EVERSTEAD
SHOP DRAWINGS/SUBMITTAL REVIEW

JOB No.	3008820
DESCRIPTION	C&H - #153 Cobey Creek
JOB ADDRESS	3546 SE Corbin Dr.
CITY	Lee's Summit, MO
DESIGNER	Scott Clevenger
DATE	12/14/2021

ROOF TRUSS LAYOUT

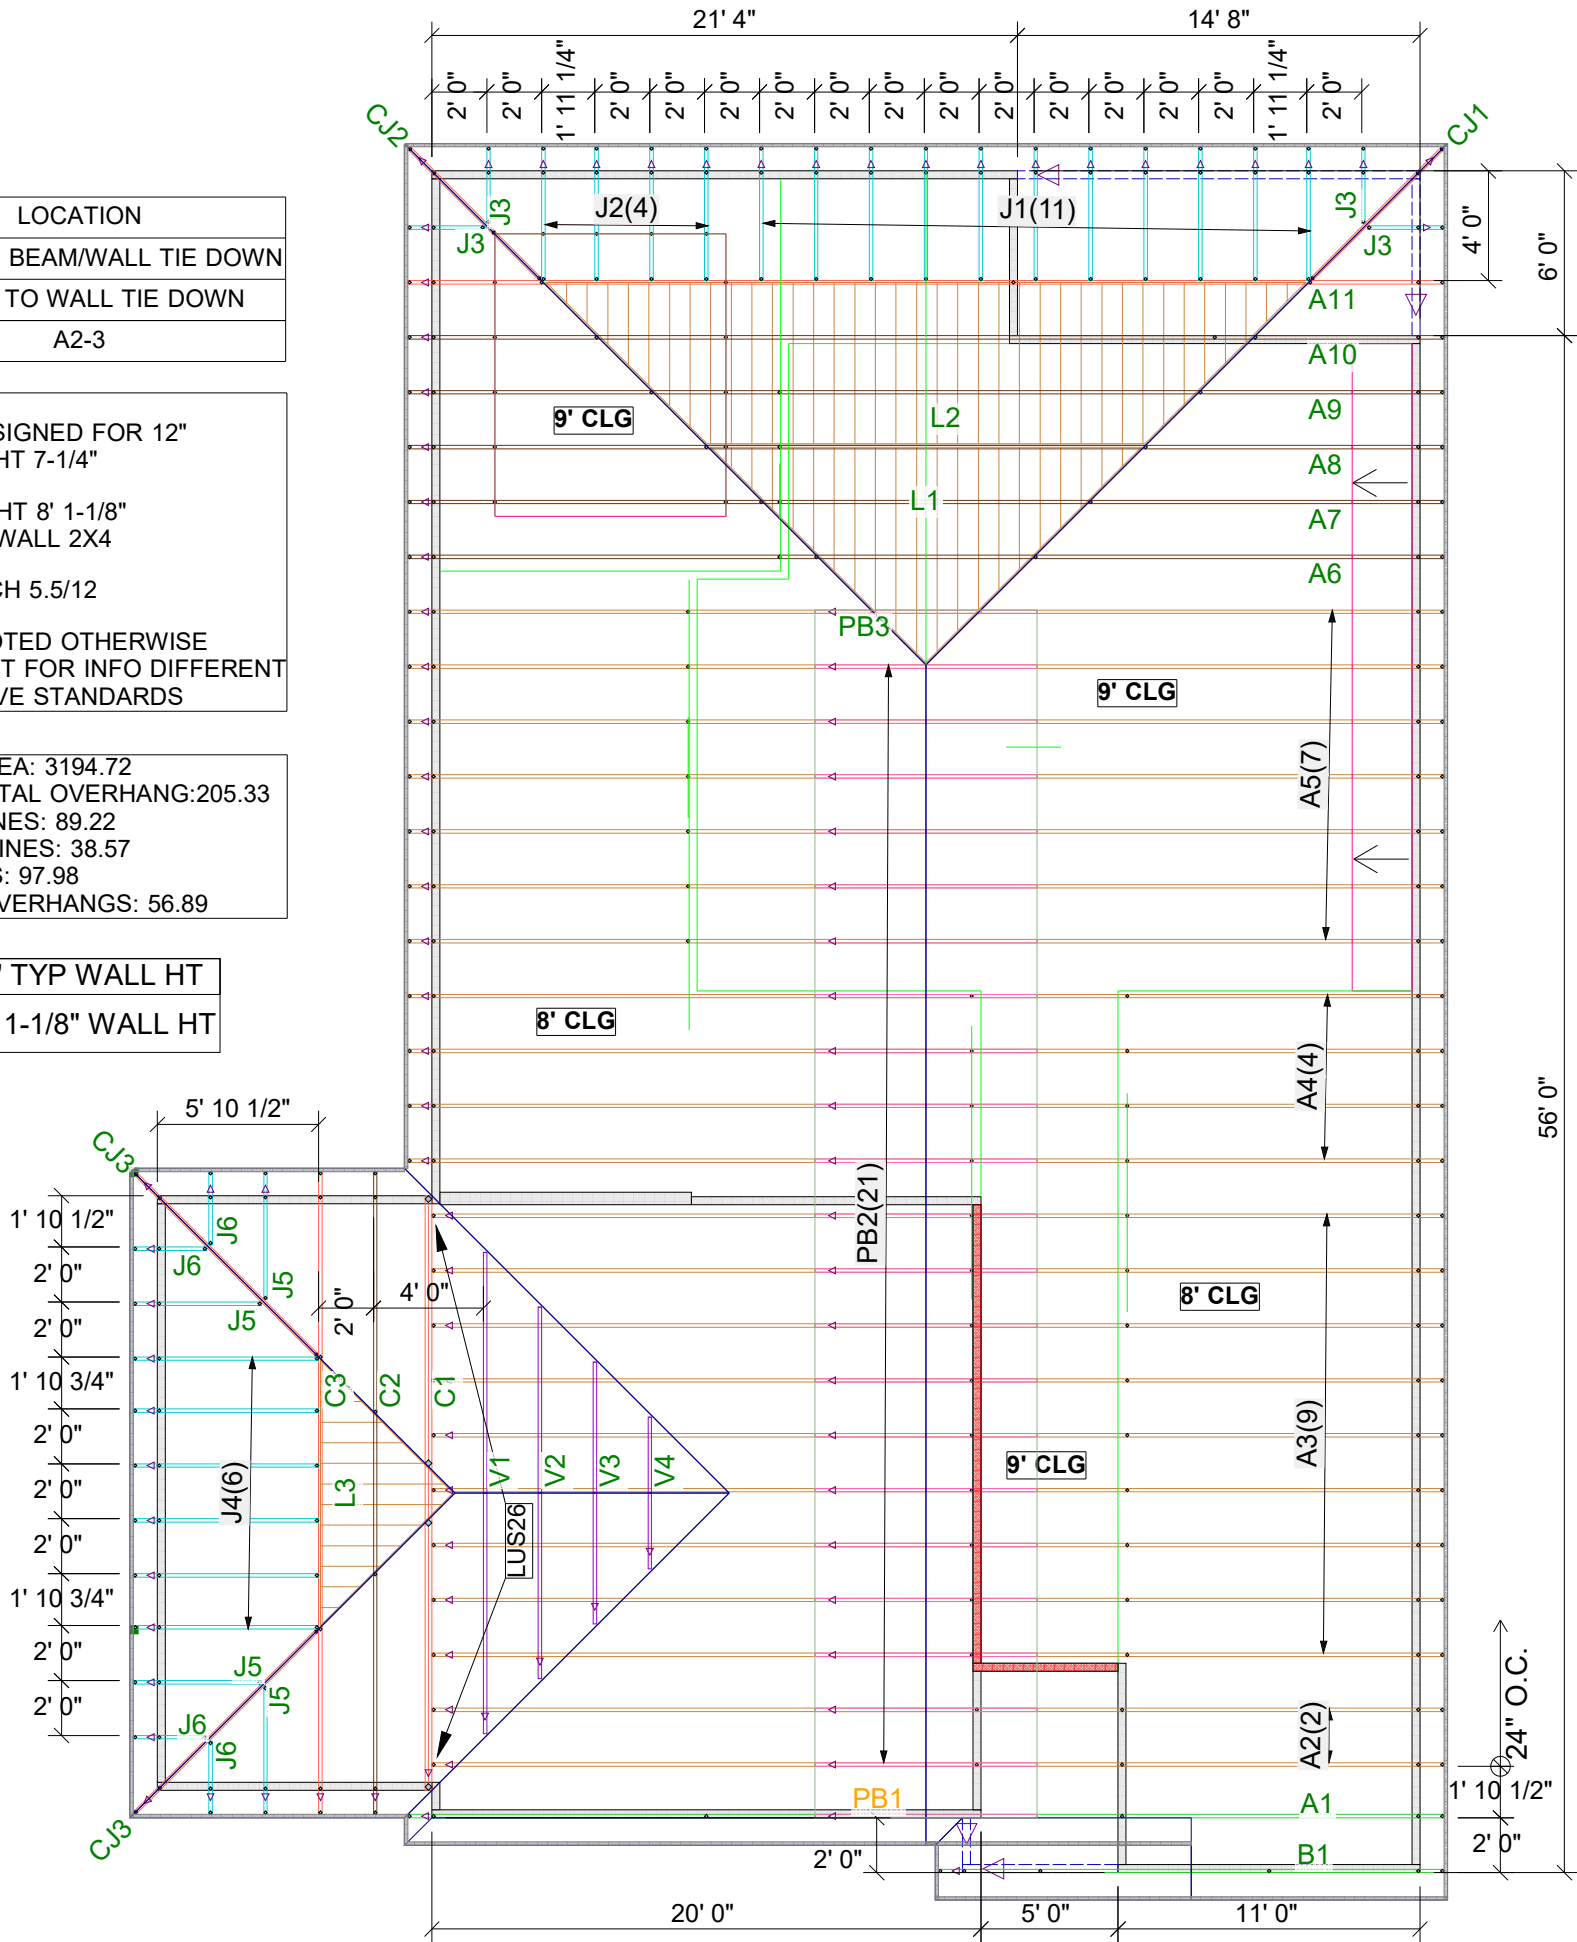
APPROVED
